CITY OF ALBUQUERQUE

RE: **8500 Glendale Ave. NE**
Permanent CO - Approved
Engineers Stamp Date; 12/4/20
Certification Stamp Date; 5/16/21

DRAINAGE AND TRANSPORTATION INFORMATION SHEET (REV 11/2018)

Concrete Scour Wall 3/8" Pump Mix in 8" wide trench with rebar along east property lines. Extend to ESB

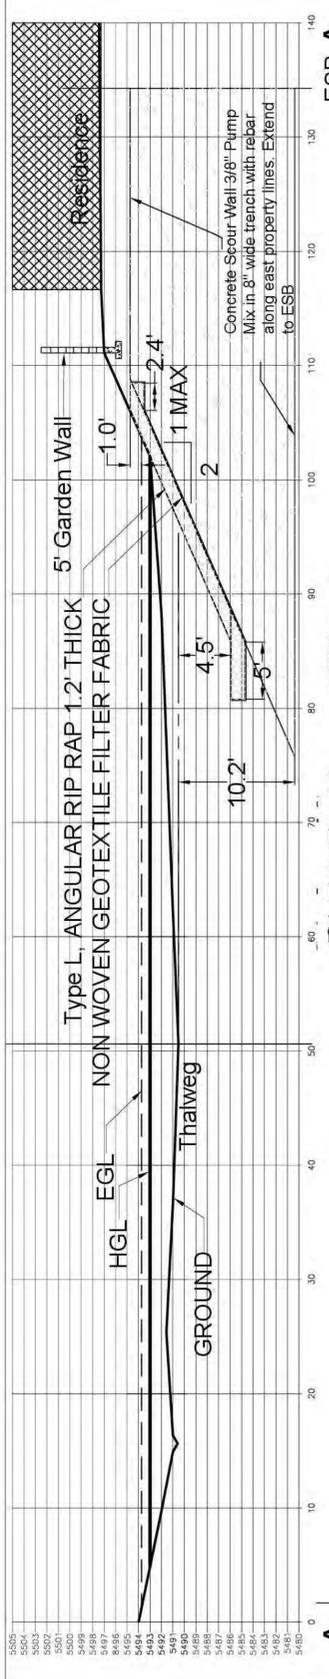
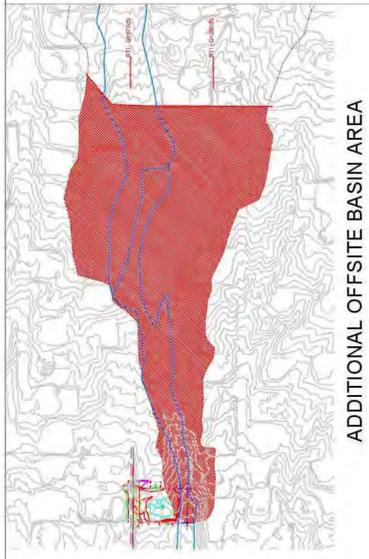
The construction of the scour wall does not match the approved drawings nor do they match City standards. After expressing concern with this you have stated that you are willing to certify this design. Therefore, based solely upon the information provided in your certification received 5/20/2021 this plan is approved for Certificate of Occupancy release by Hydrology.

Please note based on our discussion on 5/28/21 this approval is contingent on the slope of the scour wall must be seeded with native seed mix per City specification 1012.2 to help stabilize the slope. Also the property owner is responsible for maintaining the scour wall up to replacing it if necessary.

The approved design of the scour wall called for the installation of Type L (9" mean particle size) angular rip rap in a 1.2' thick layer. The top of the rip rap layer was to extend below grade in the arroyo channel to an elevation 4.5' below the thalweg of the channel. Cut stakes for this area were provided by Dehler Surveying. A site visit I completed on 9/9/2020 showed the excavation for the placement of the below grade material met or exceeded the design requirements. I have attached a photo of the excavation. The recycled concrete placed in the excavation area does not meet the exact particle size distribution for Type L rip rap as presented in Section 109 as much of the material is larger than the 9" mean particle size and some of the material is smaller than the 3" minimum (see photo 10/5/2020). However, I believe the material will meet the intent for scour protection based on the larger size and also the length between the toe of the slope and the south edge of the scour protection is more than twice the design requirement of 5' (see G&D plan B20D067).

The rip rap material placed on the slope was examined on 3/3/21 for the purpose of certification of the project. The material again is significantly larger than the 9" Type L requirement. There were some piles of dirt and construction debris on the surface of the rip rap. This material was not addressed in the certification as it does not affect the integrity of the scour wall.

I will certify the material and construction of the scour wall based on the above information. I would like to thank your staff for questioning this project as it was not constructed under the required work order procedures. I picked up this project after it had been started and was unaware of this requirement.
